**DEVIATION REQUEST
 AND DECISION FORM**

Project Name : Grandwood Ranch
 Schedule No.(s) : 6119000003
 Legal Description : S2N2, EX PT TO HIGBY RD CONV BY REC# 205092691 W/MR SEC 19-11-66

DEVIATION NO. 4 (Rev. 4/17/2020) - A deviation from the standards of or in Section 2.3.2 of the Engineering Criteria Manual (ECM) is requested for the proposed extension of Furrow Road from Minglewood Trail to Higby Road (a proposed Rural Major Collector per the MTCP). Please refer to Deviation Exhibit 4.

GRANDWOOD RANCH DEVIATION REQUEST EXHIBIT

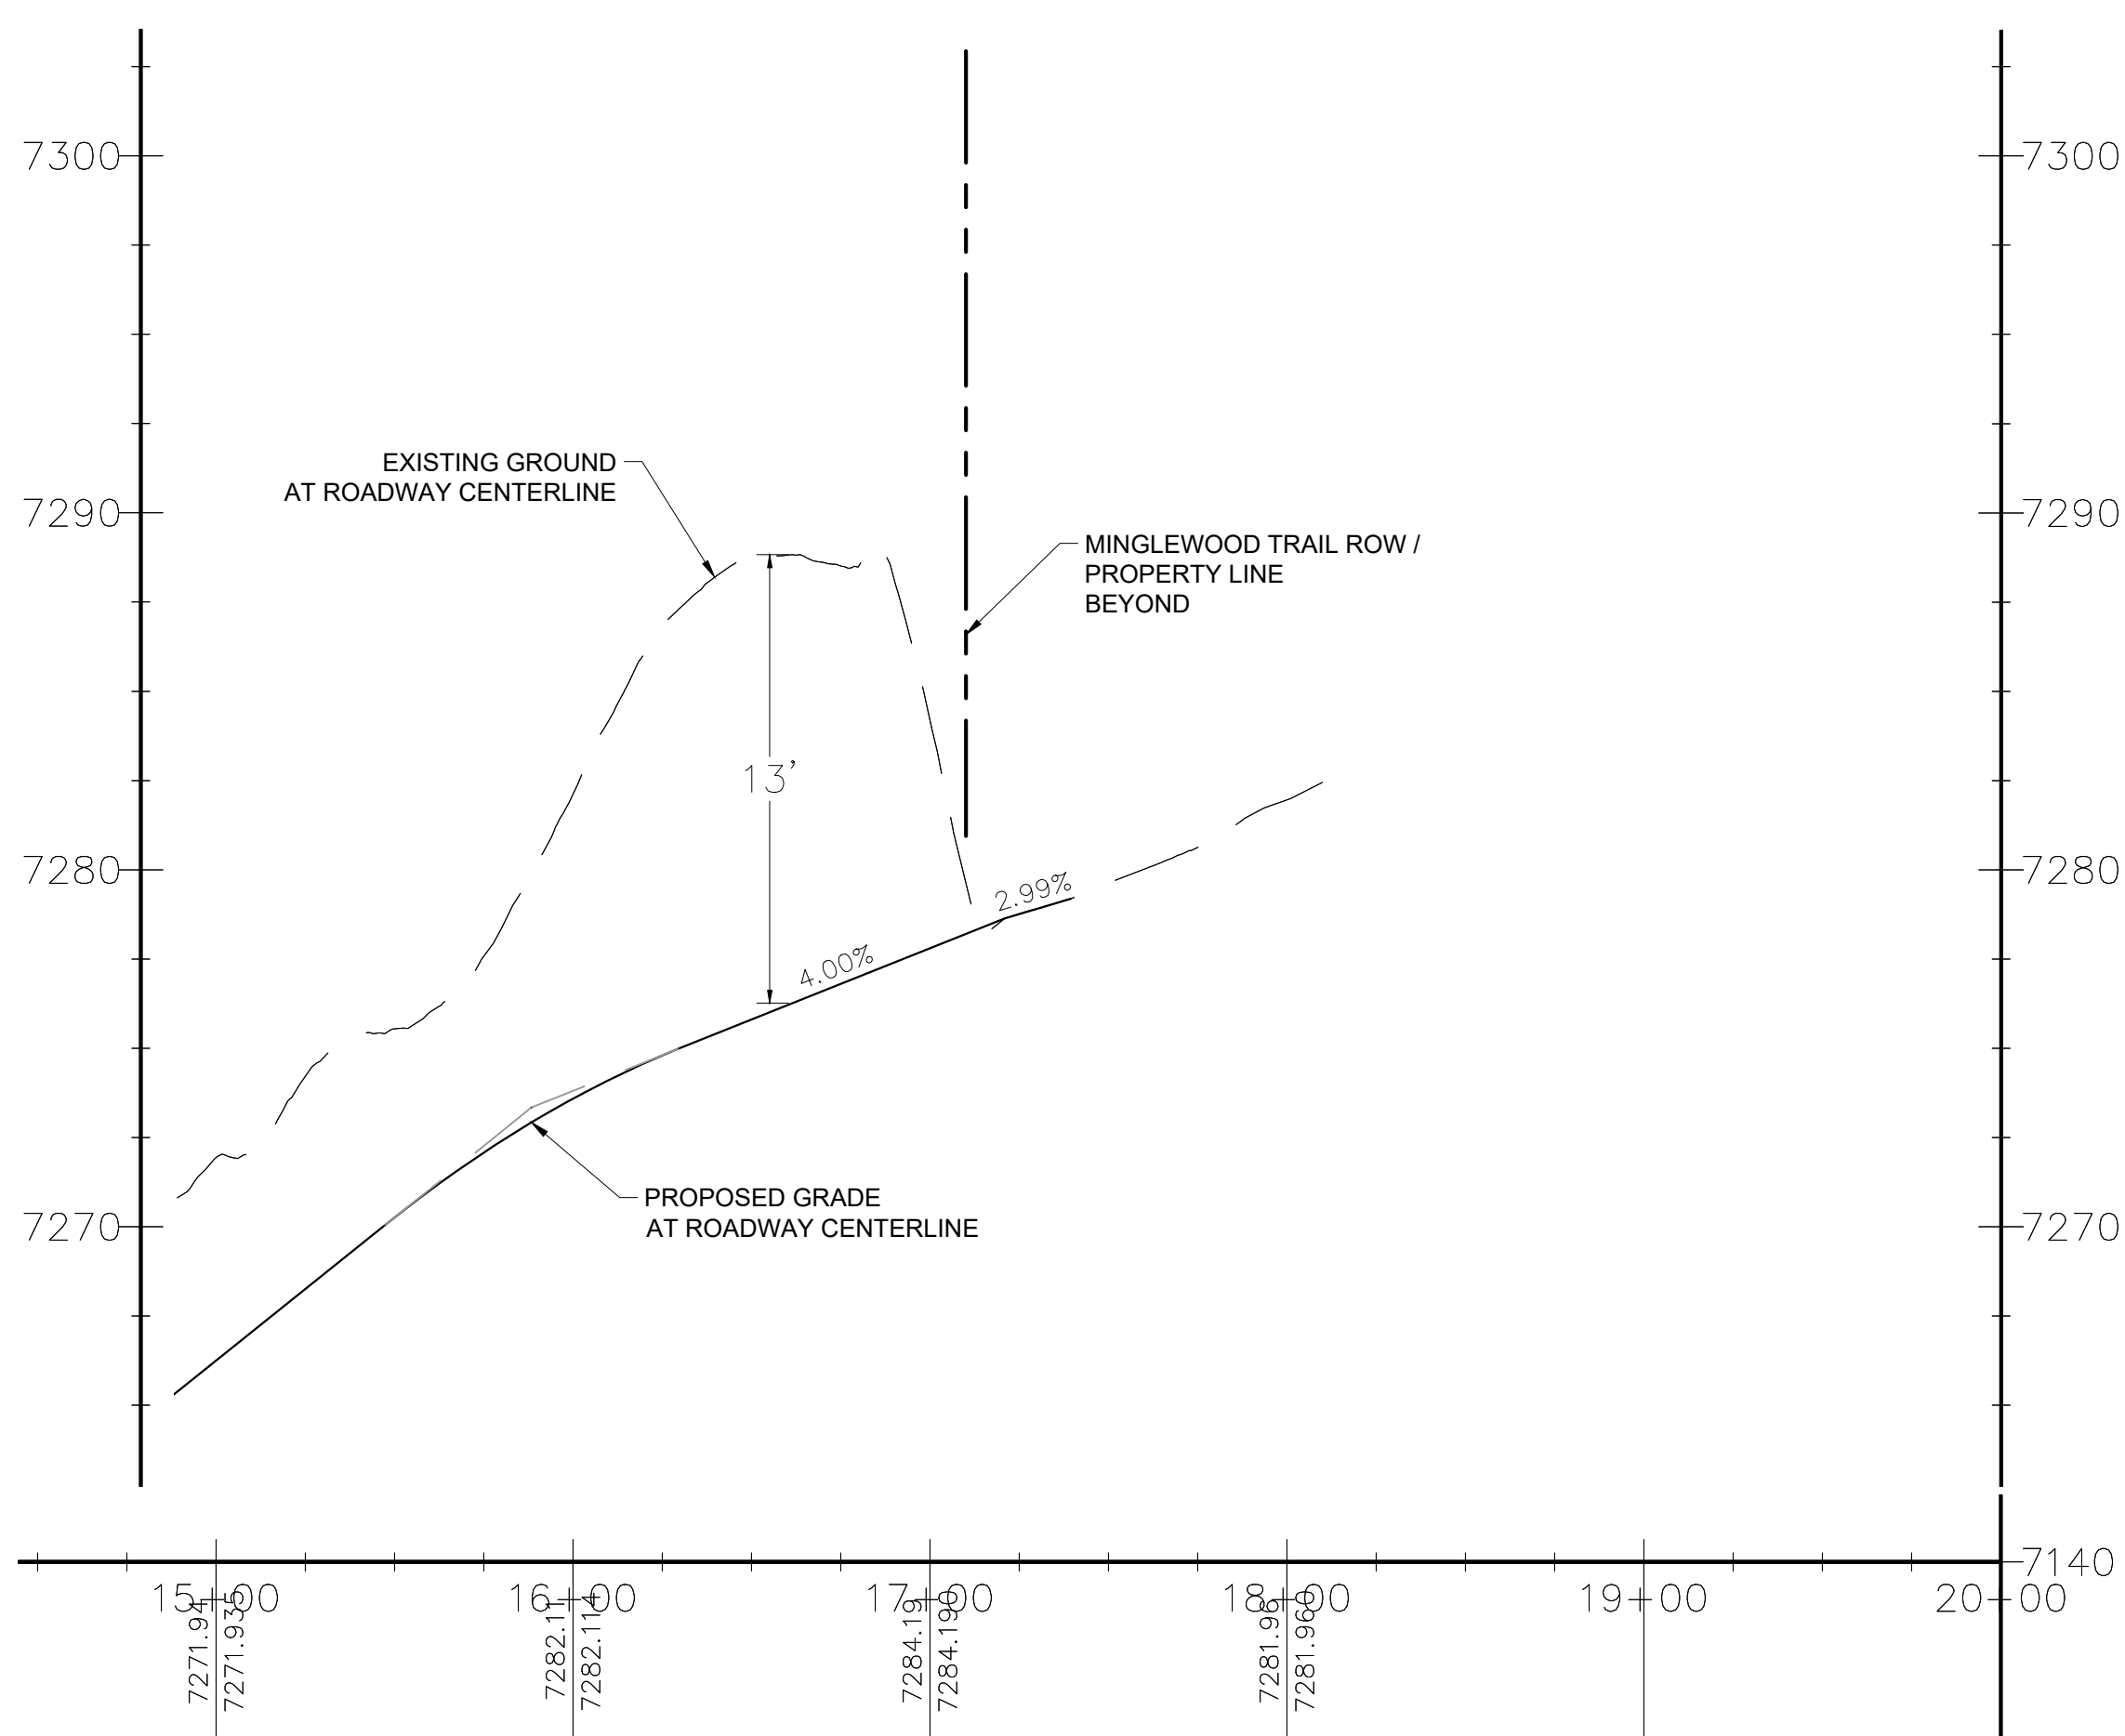
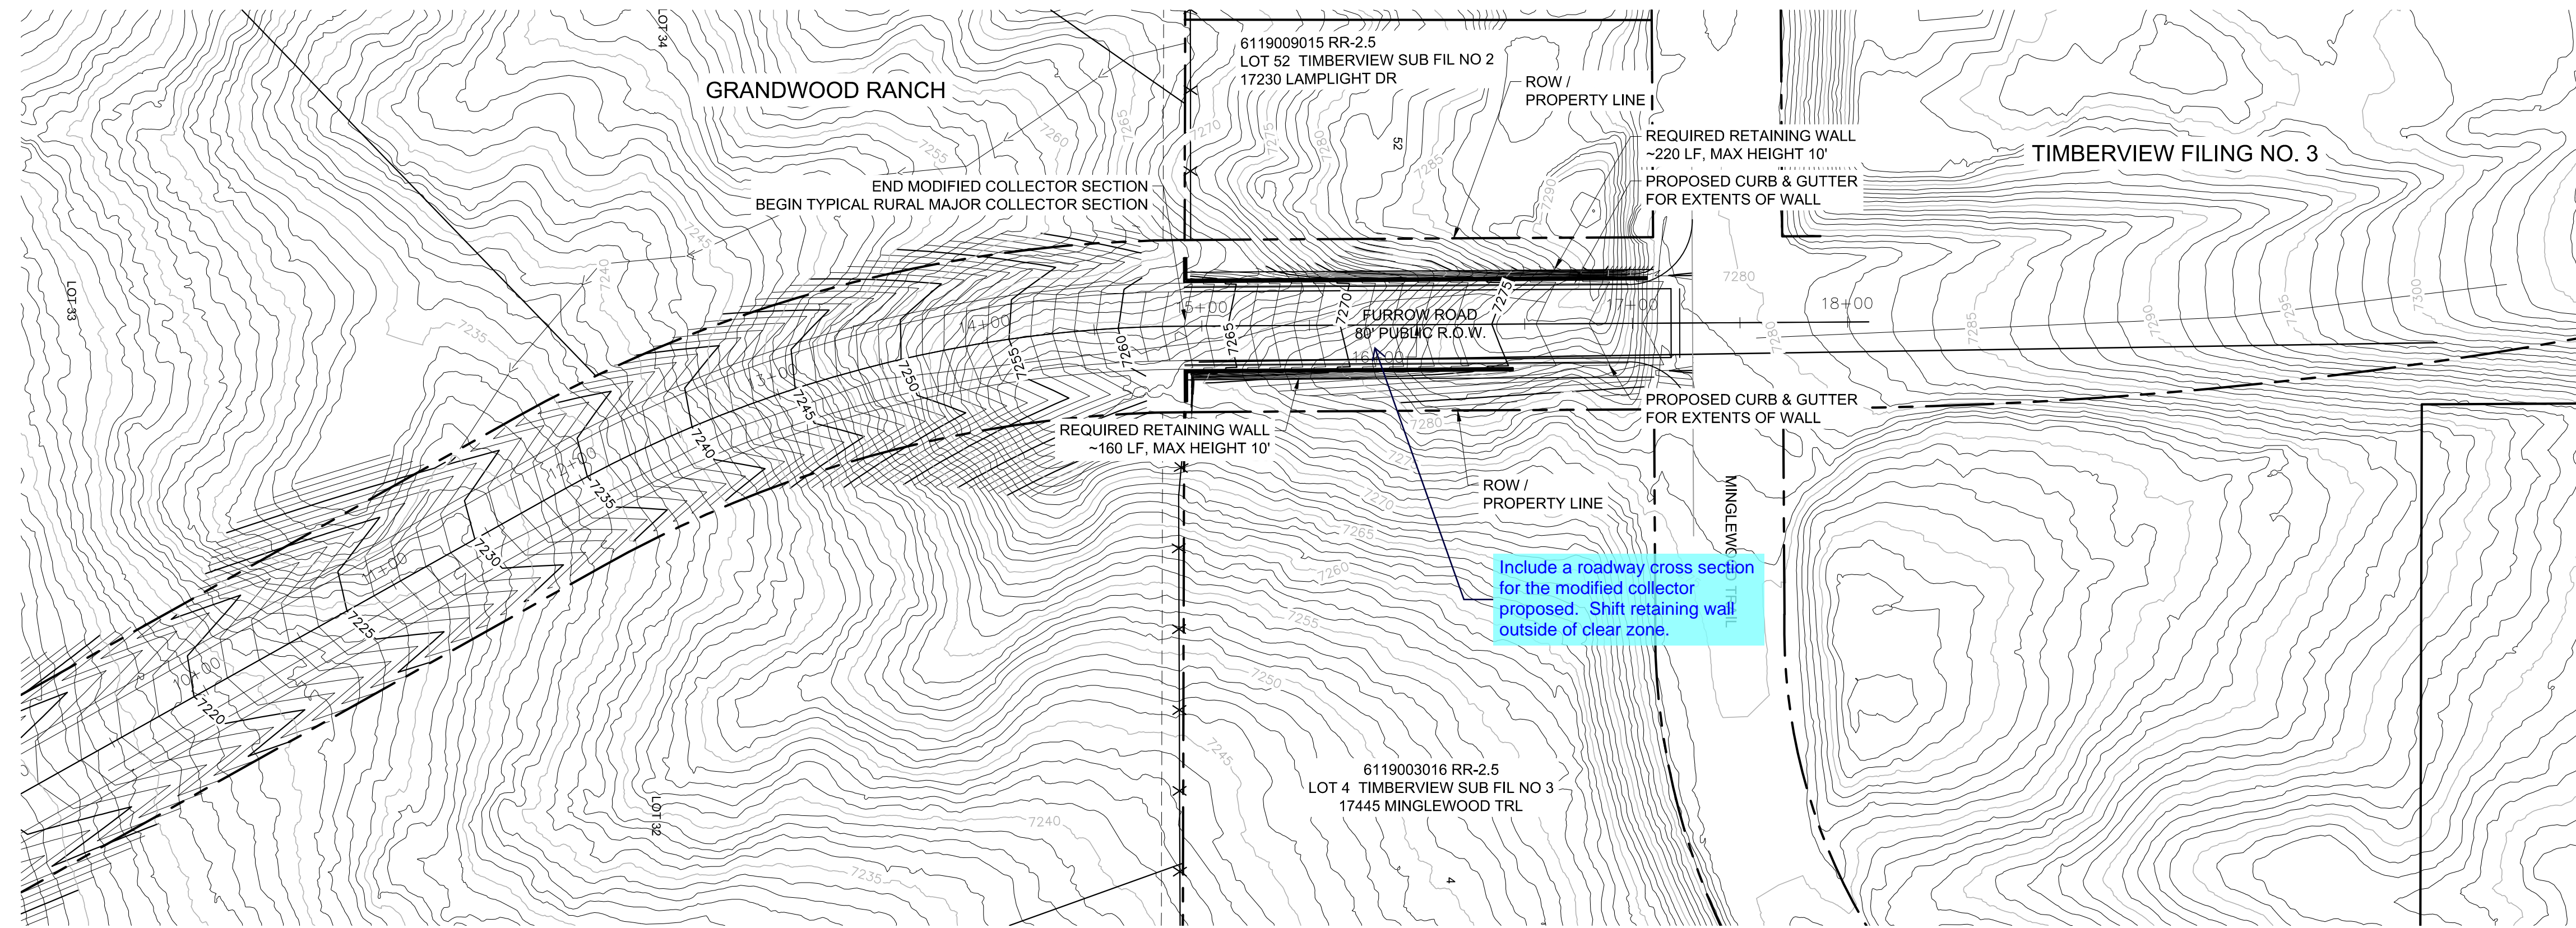
Elaborate. Urban collector sections have a clear zone of 14'. The proposed alternative shall maintain the clear zone. How will the clear zone transition to the major collector clear zone of 20'.

Typical cross section should include guard rails.

Elaborate. Who is expected to maintain the retaining wall?

Deviation Exhibit 4

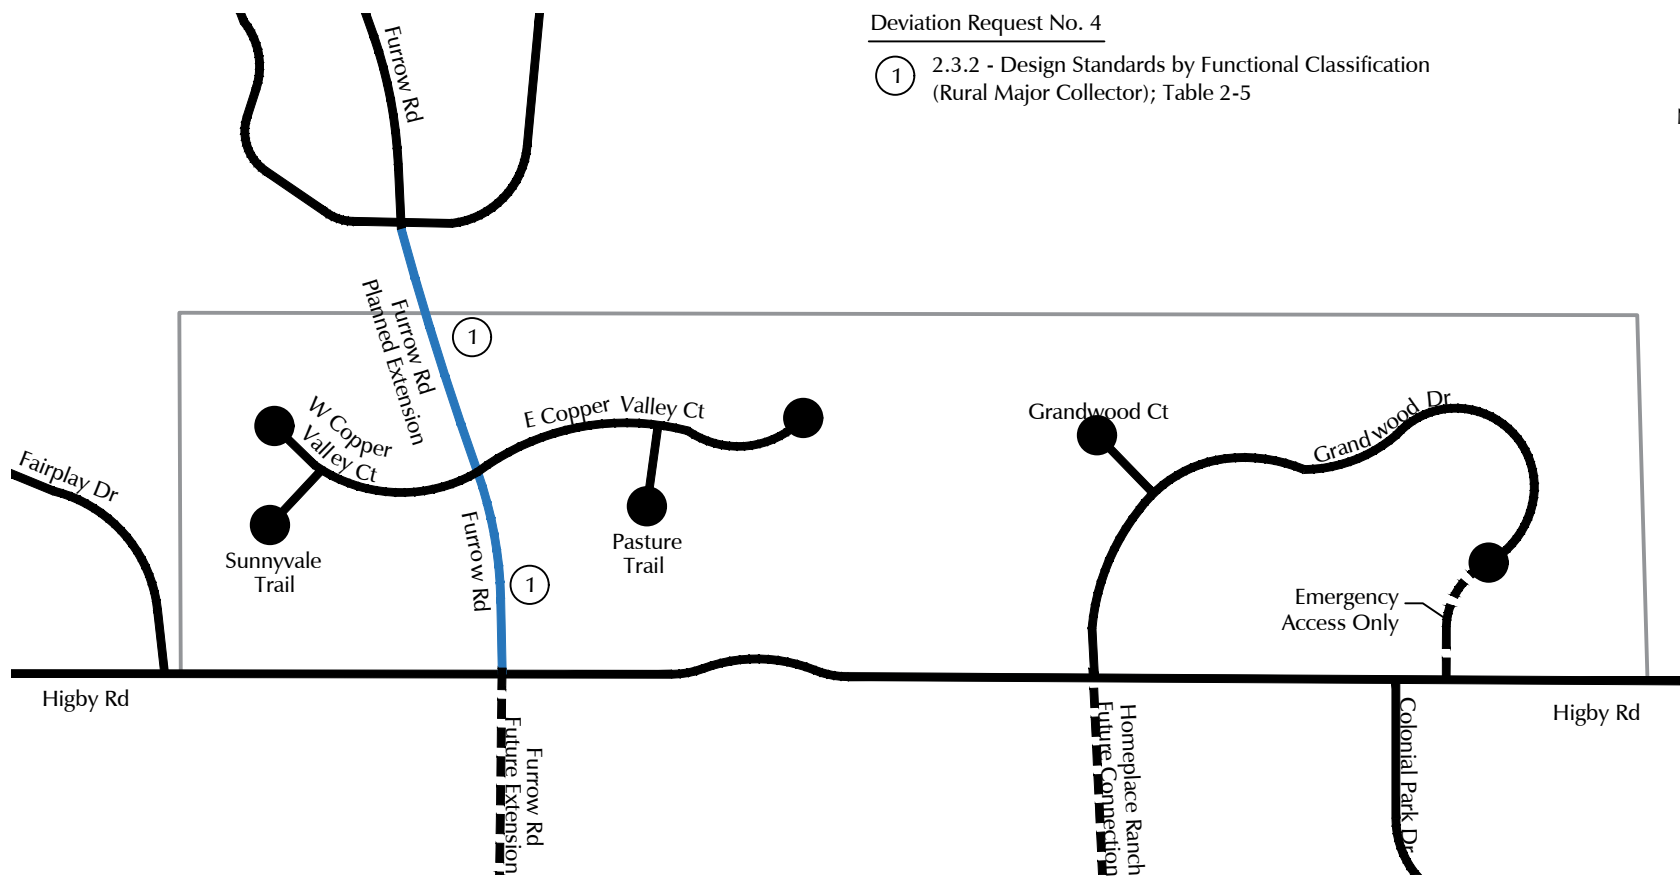
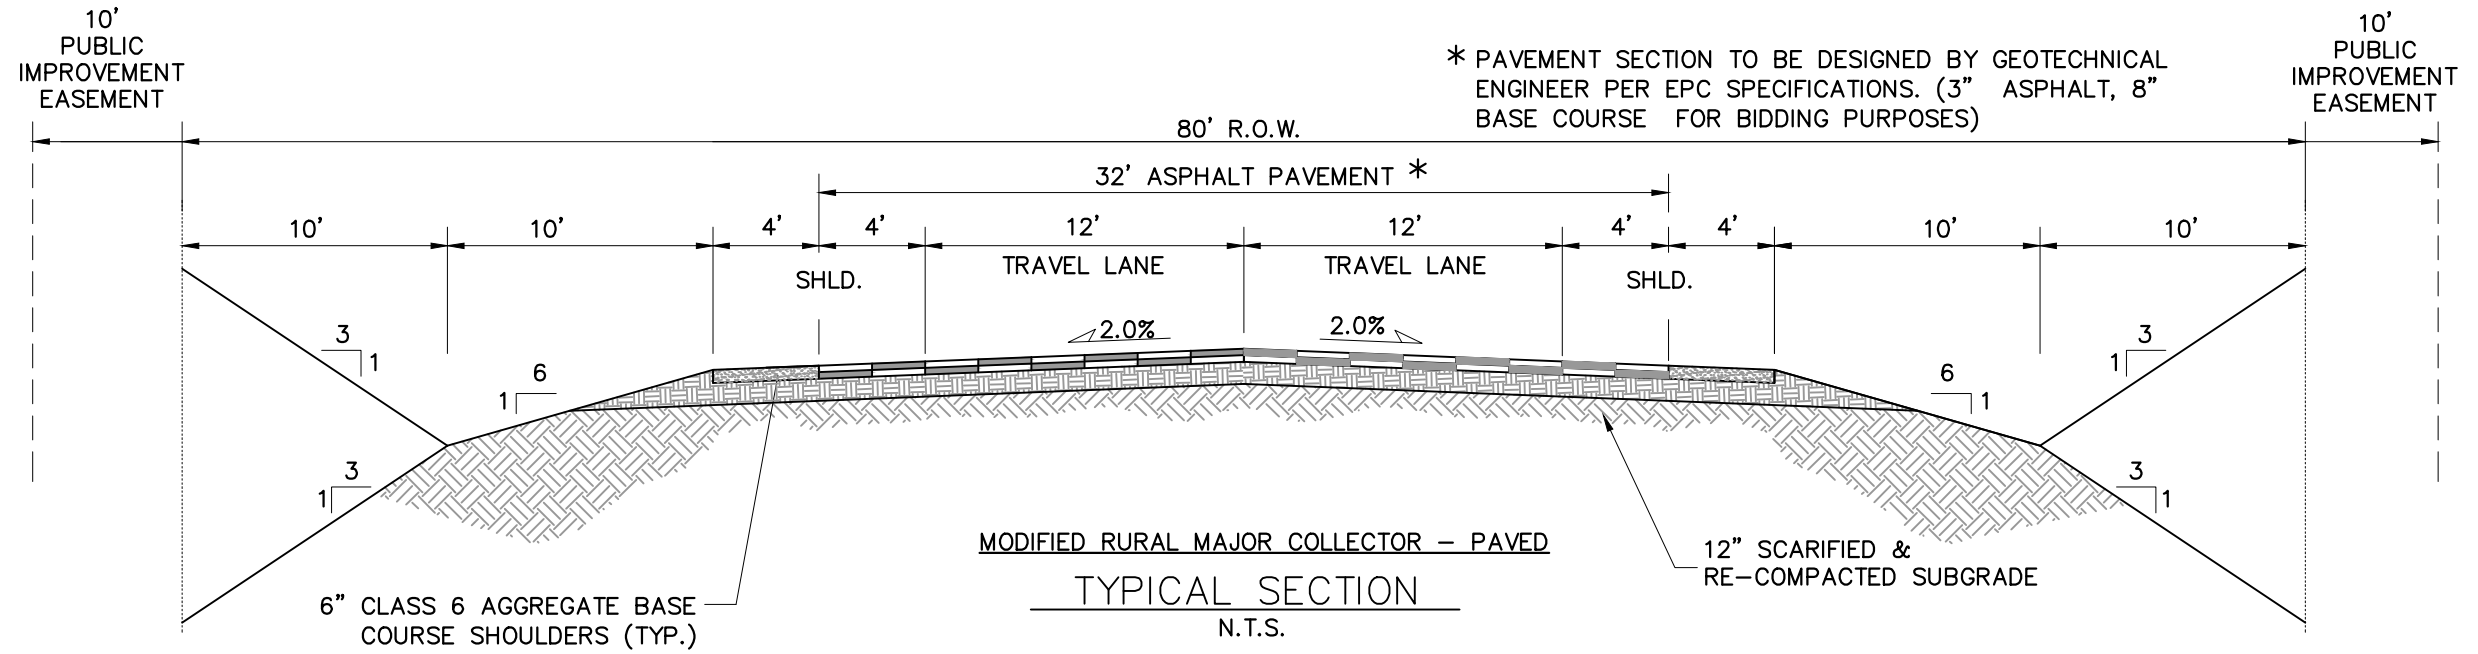
proposed alternative shoulder is not consistent with the cross section attached.

Deviation Exhibit 1
Proposed Intersection Spacing
 Grandwood Ranch (LSC# 185020)

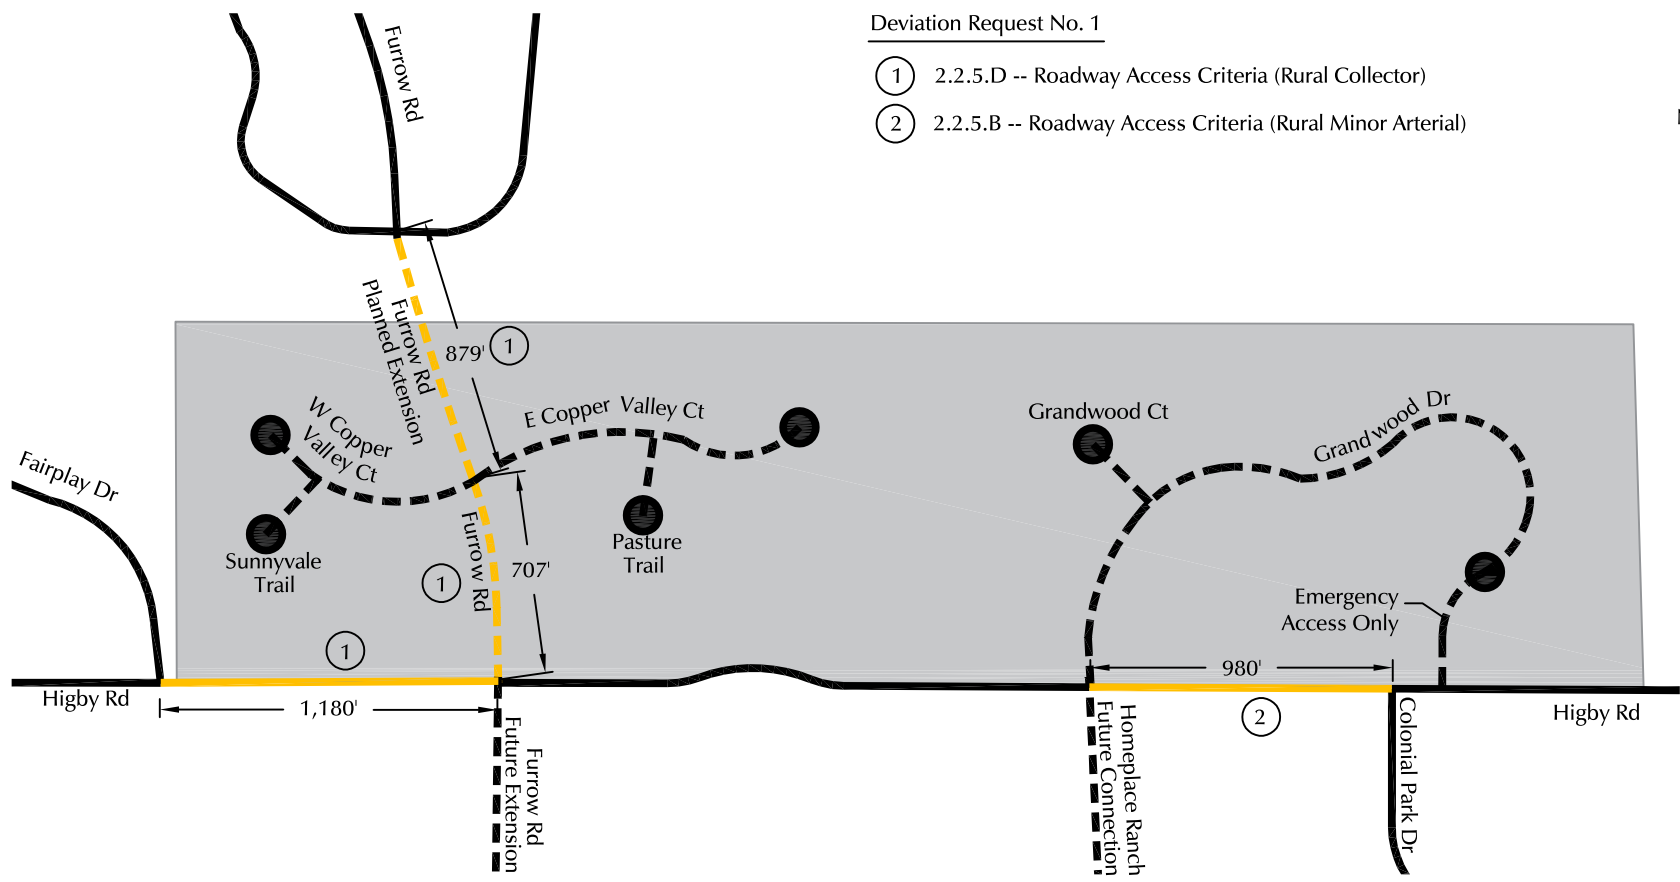
update to match exhibit or vise versa.
